Access Compliance Report Public Rights-of-Way (Pedestrian Signals)

Main Street: PROSPECT_AVE Cross Street: FAIRHAVEN_AVE Location: SW

ADA ID: SGAT211021103322 Signal Type: One Push Button-Non APS Overall Compliance: No Severity Scores: BTN 1: 35 BTN 2: N/A No BTN: N/A

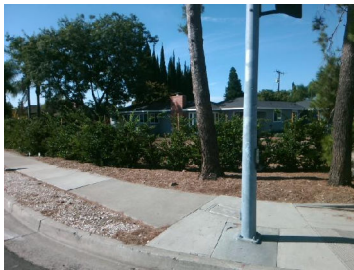
OC Std/PROW: MUTCD 4e.08, R404.2, R404.3

Possible Solutions: Replace Signal Push Button With APS Button. Remove & Relocate Sign.
